MAINE DEPARTMENT OF HUMAN SERVICES
APPLICATION FOR PRIVATE SEWAGE DISPOSAL PERMIT

Town: AUGUSTA	Street, Road, etc.: RT 17 If on water body, give name:	Plumbing Permit No.: 8843	Date of Plumbing Permit: 4/4/78

Subject: Waiver to the Maine Plumbing Code, Part II,
Newcombe property, Route 17, Augusta

Site Plan — Scale 1" = 100 Ft. or 1" = 50'

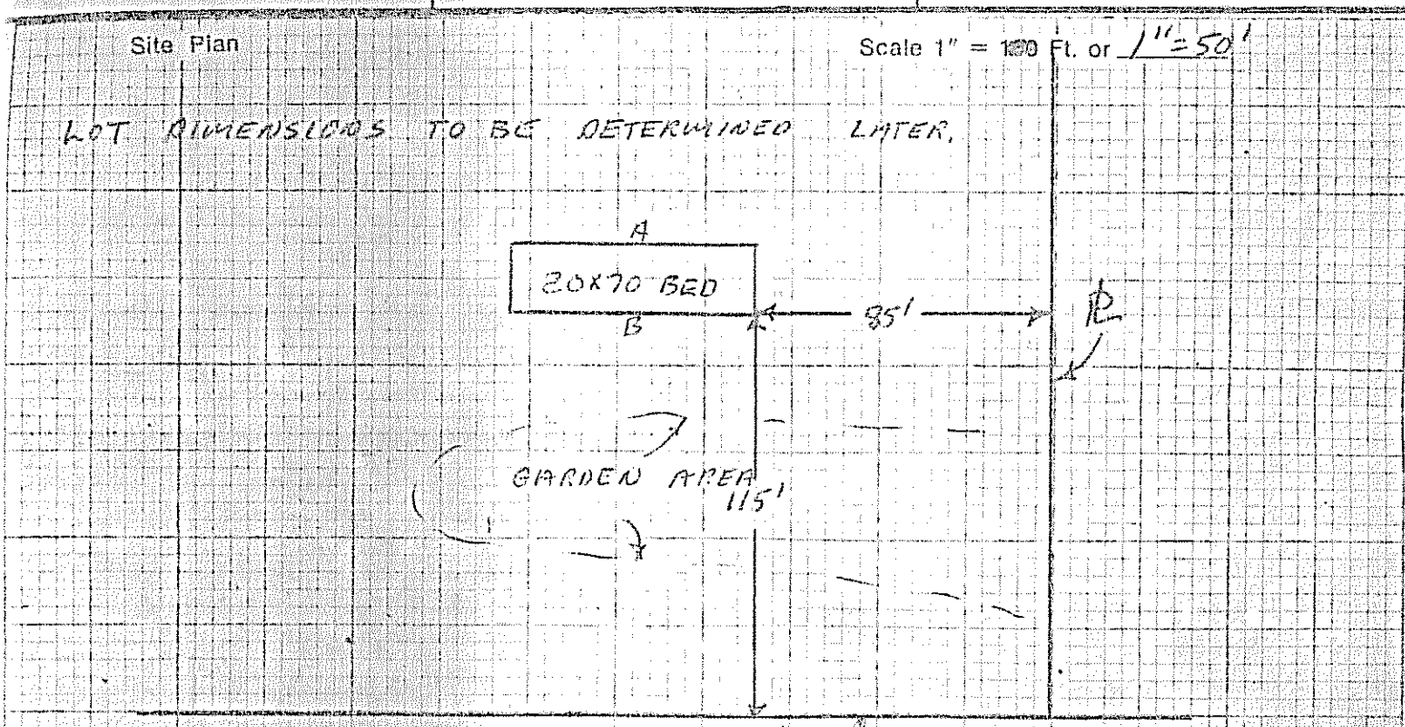
c) Proper setback distances to the proposed dwelling facility were not included. An approximate location should be indicated on HHE-200.

Private Sewage Disposal Plan — Scale 1" = 20' or _____

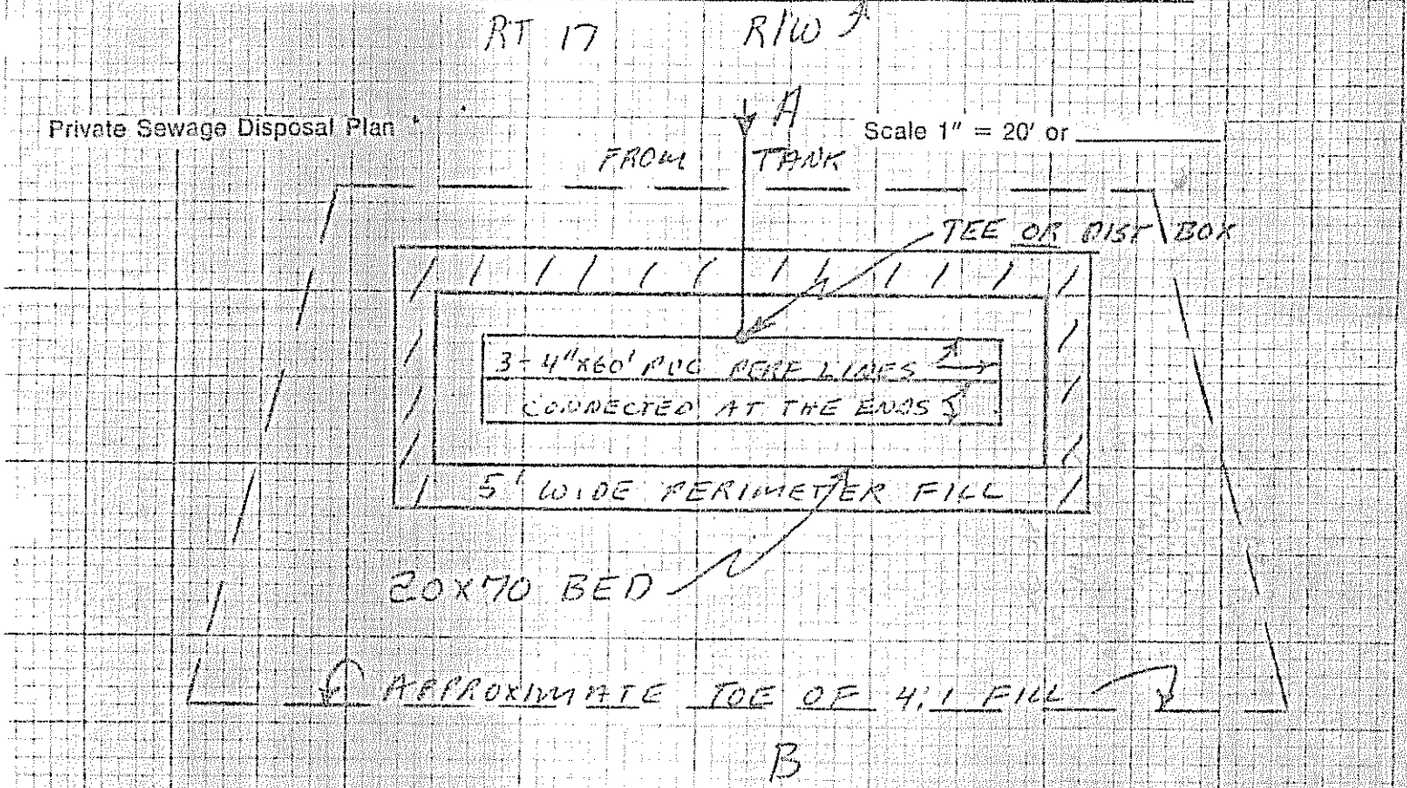
This will acknowledge receipt of a waiver request and a plan with soils information by William W. Rideout, Site Evaluator, showing the proposed sewage disposal system for the subject project. It is not in compliance with the Maine Plumbing Code, Part II, because of installation of a 70'x20' bed disposal system on 9C soils, the reason for the waiver request.

a) Treatment tank size. Note: a 1000 gallon tank is recommended in the approval letter.

The installation of a 1000 gallon septic tank to be followed by a 70'x20' disposal bed system.

Subsurface Absorption Area Cross-section — Scale: Vertical — 1" = 5' or _____ Horizontal — 1" = 20' or 1" = 10'

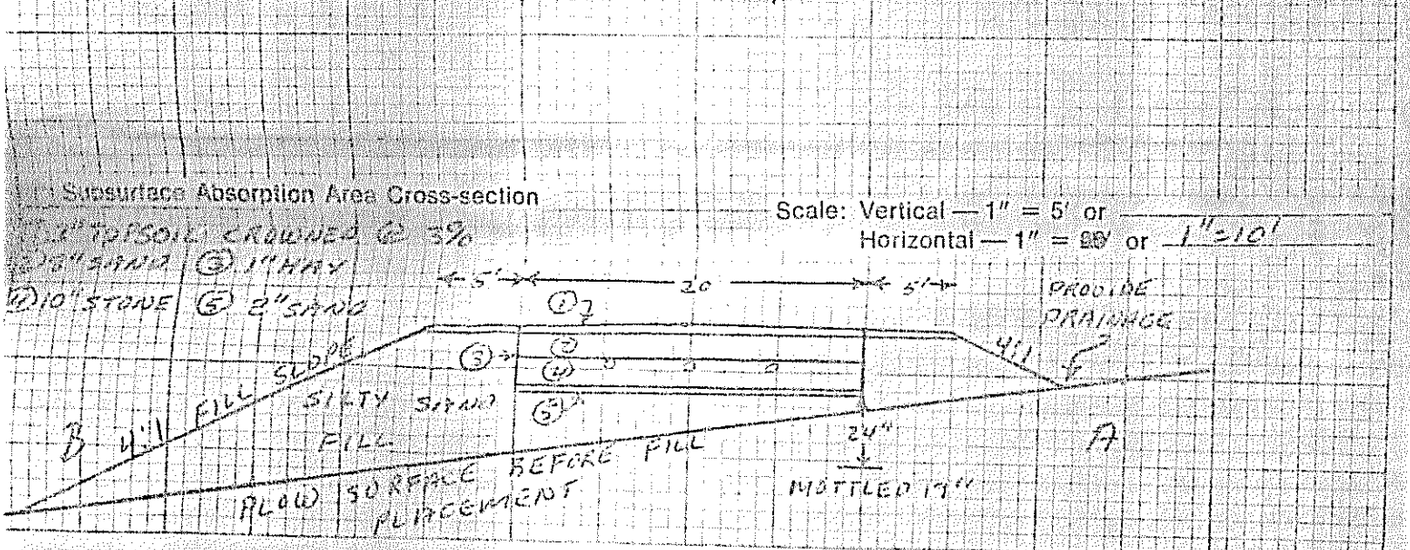
b) Fill for the downhill side was omitted on page 1.

At least 29 inches and 44 inches of fill shall be applied on the uphill and downhill sides of the bed, respectively. This fill shall be of a texture similar to the original soil and will provide the required 24 inch separation between the bottom of the disposal bed and the seasonal high water table and impervious layer. The fill must be extended in all directions as required by Section 8.7 of the Maine Plumbing Code, Part II.
